Dominion Nuclear Connecticut, Inc.
Millstone Power Station
Rope Ferry Road
Waterford, CT 06385

Docket No. 50-423
B18314

Millstone Nuclear Power Station, Unit No. 3
Technical Specifications Change Request 3-11-00
Reactor Coolant System Heatup and Cooldown Curves

FIGURE 3.4-2

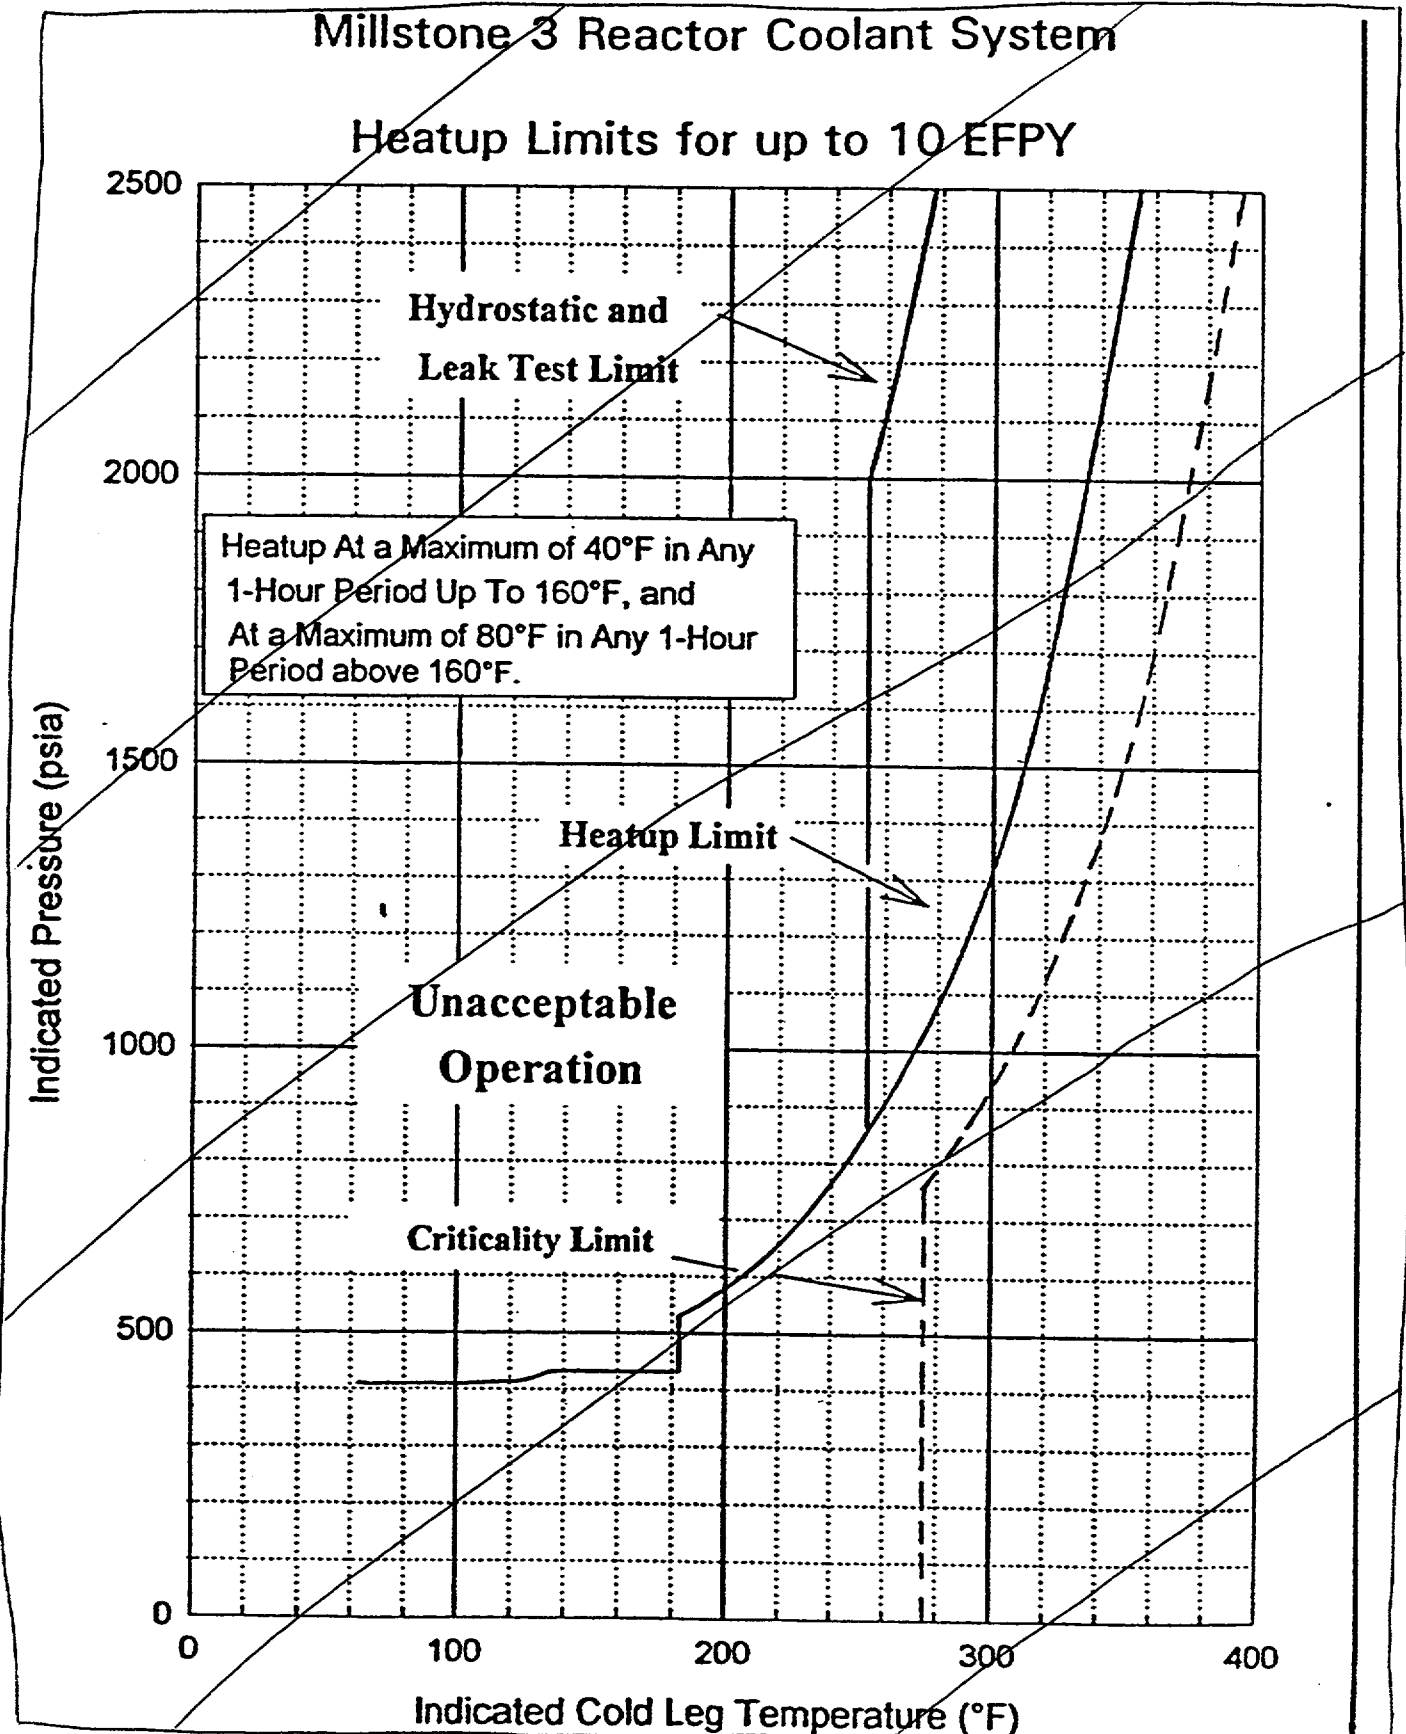
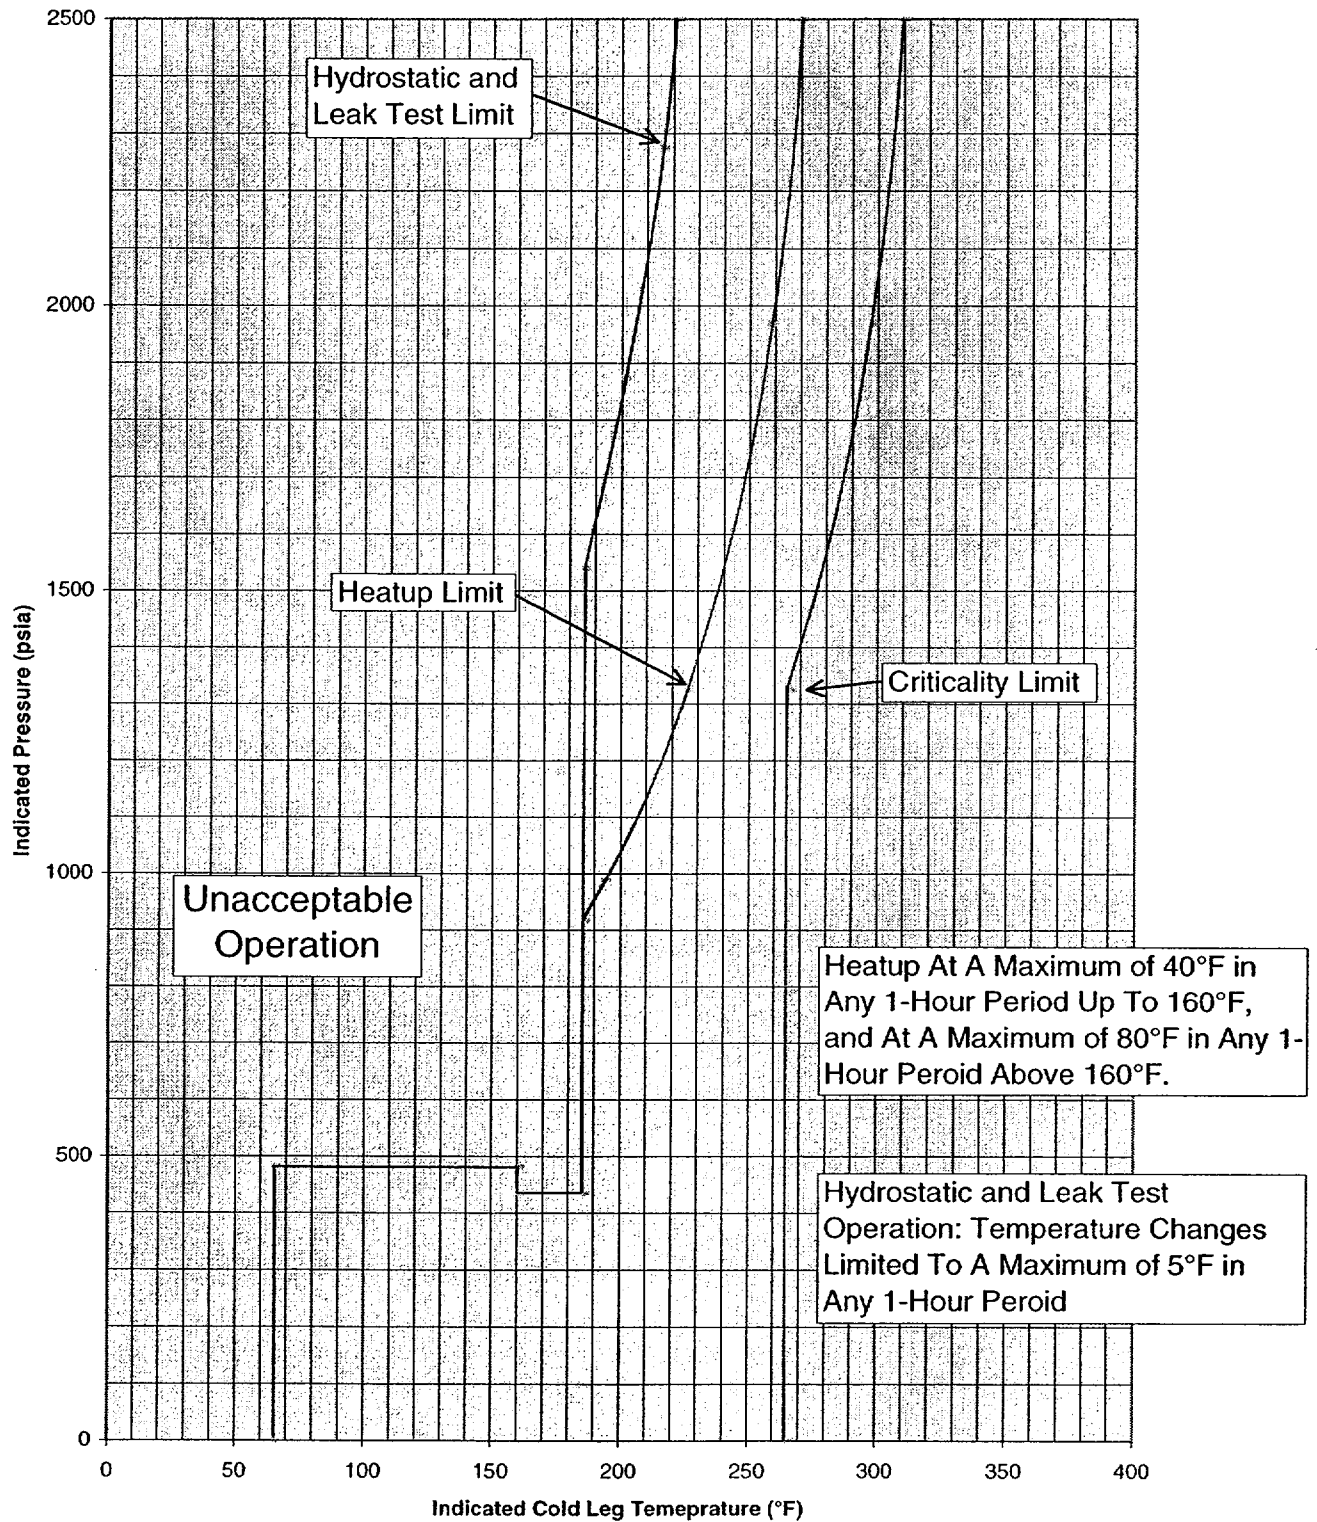
3. Figure 3.4-2 will be replaced by a new curve, based on the revised analysis, that is applicable to 32 EFPYs. The hydrostatic and leak test limit will be added to Figure 3.4-2.

Figures 3.4-2 and 3.4-3 have been replaced by new curves, based on the revised analysis. The new curves are applicable to 32 EFPYs. The hydrostatic and leak test limit has been added to Figure 3.4-2.

**Millstone 3 Reactor Coolant System
Heatup Limitations for Fluence up to 1.97E+19 n/cm (32 EFY)**

Figure 3.4-3

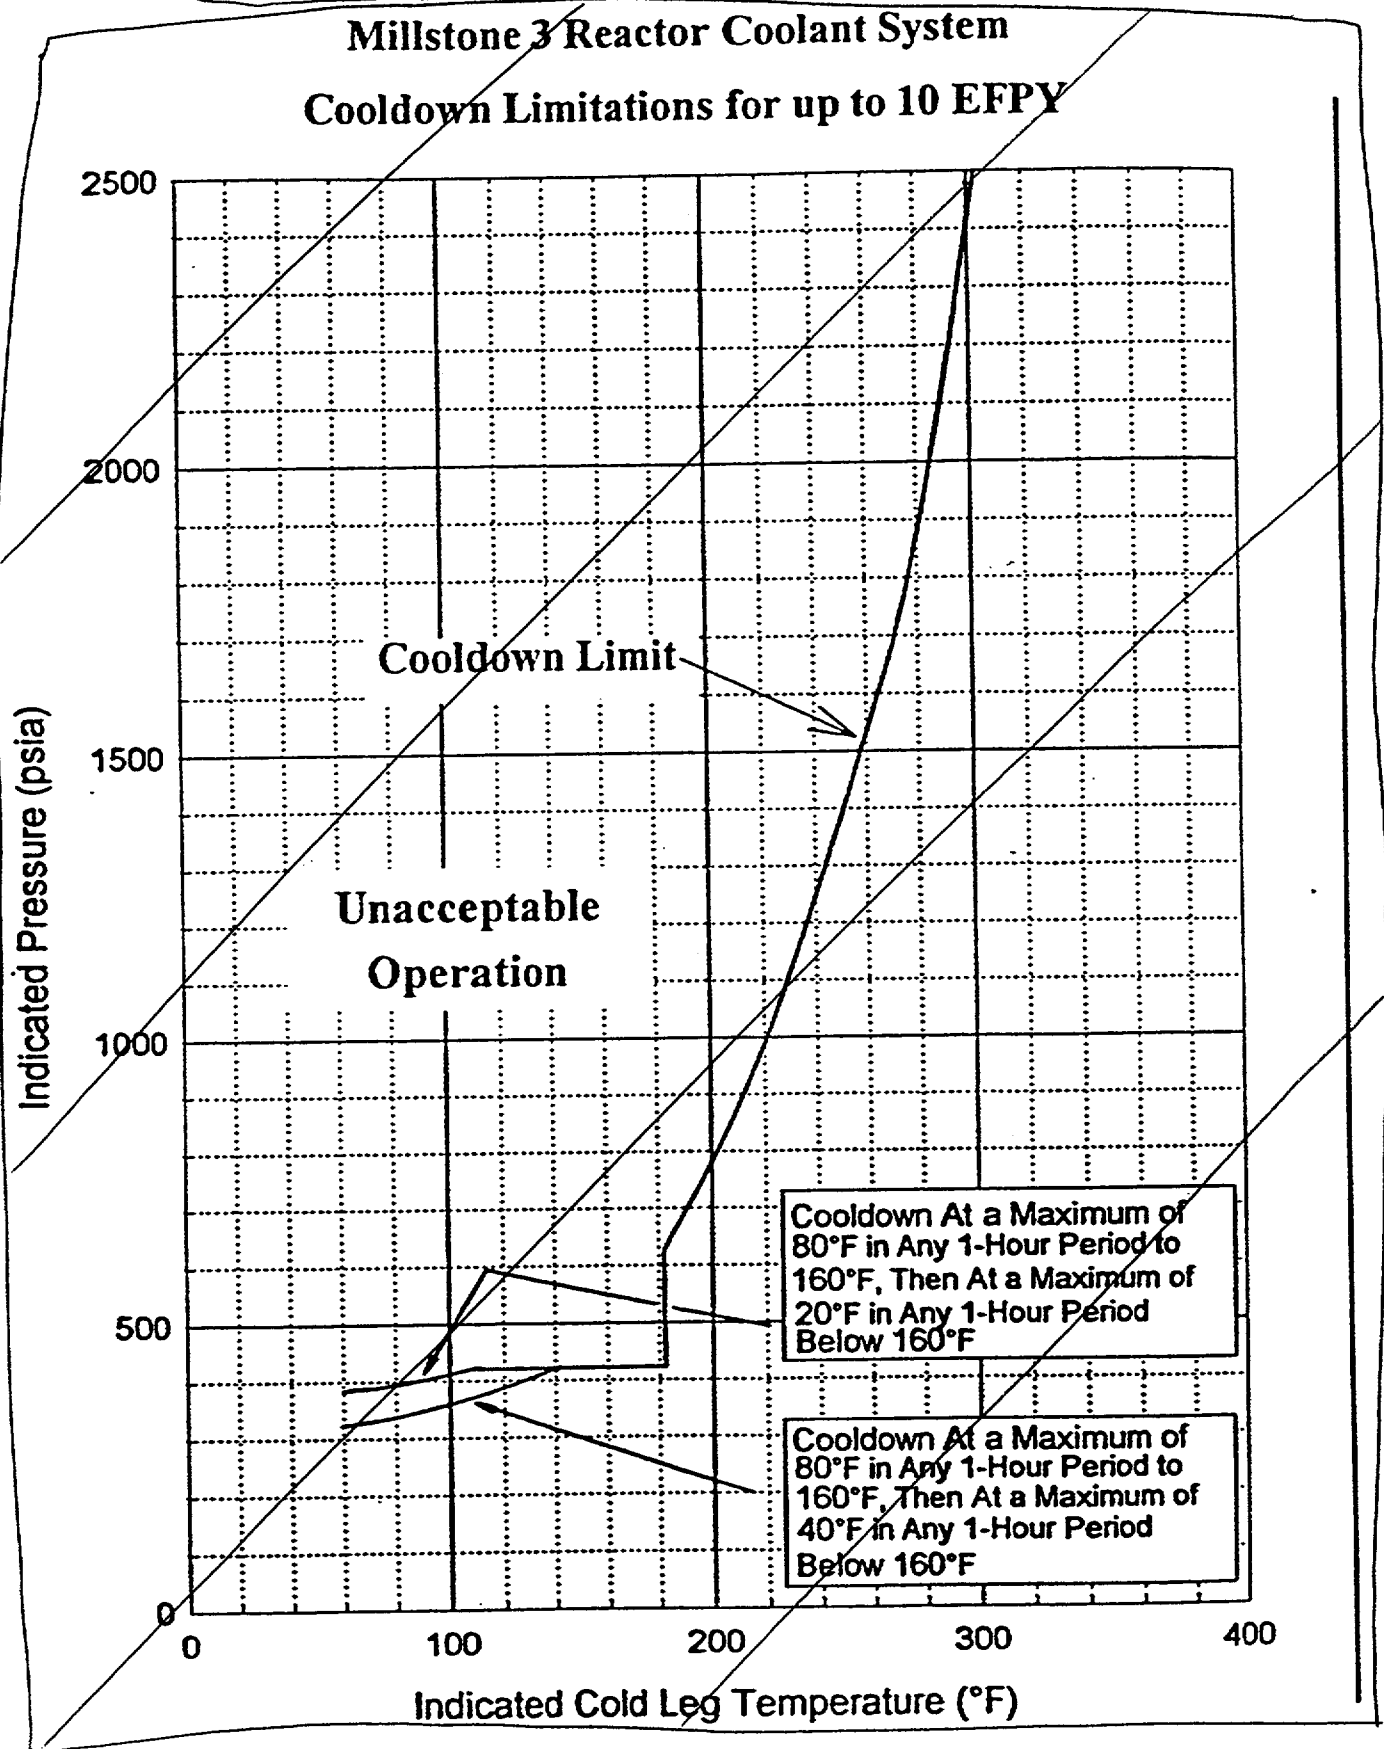
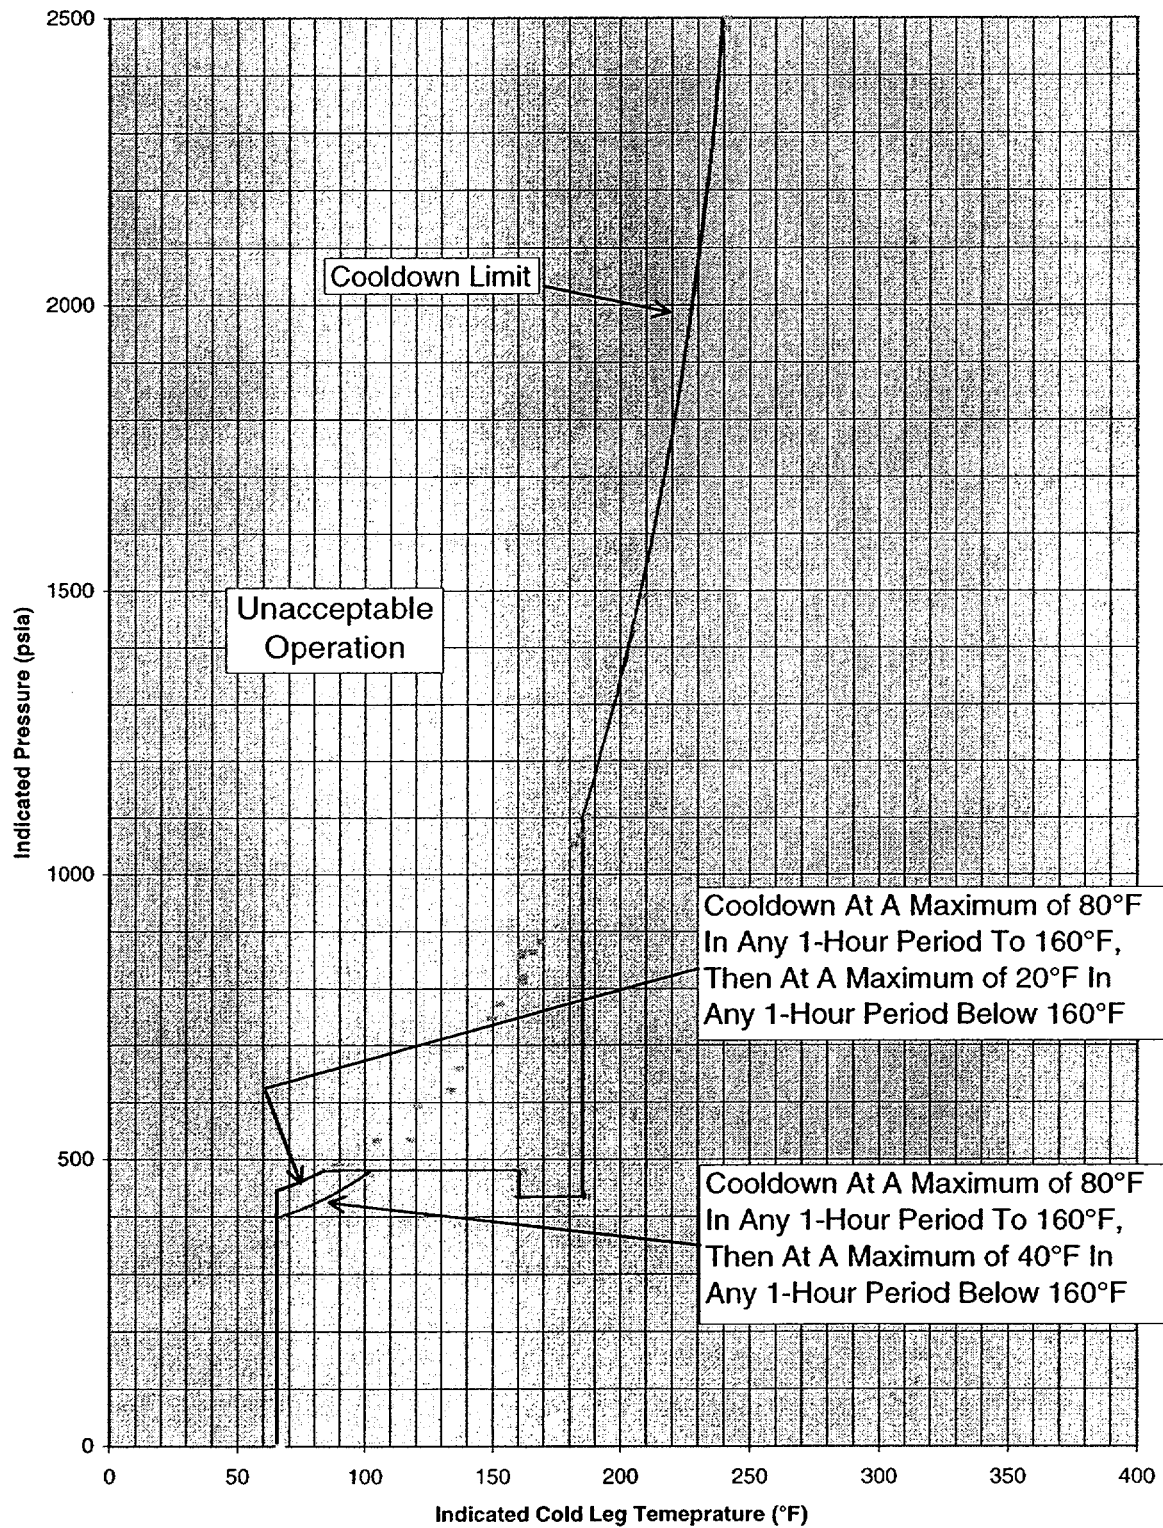
4. Figure 3.4-3 will be replaced by a new curve, based on the revised analysis, that is applicable to 32 EFPYs.
5. Table 4.4-5 will be revised. The capsule numbers and vessel locations have not been changed. The lead factors have been revised based on the evaluation of capsule X. The withdrawal column has been renamed and updated to reflect actual capsule withdrawal. A column containing fluence values has been added. The current footnote has been revised, and numerous footnotes added consistent with the proposed table changes.

Millstone 3 Reactor Coolant System
Cooldown Limitations for Fluence up to 1.97E+19 n/cm (32 EFPY)
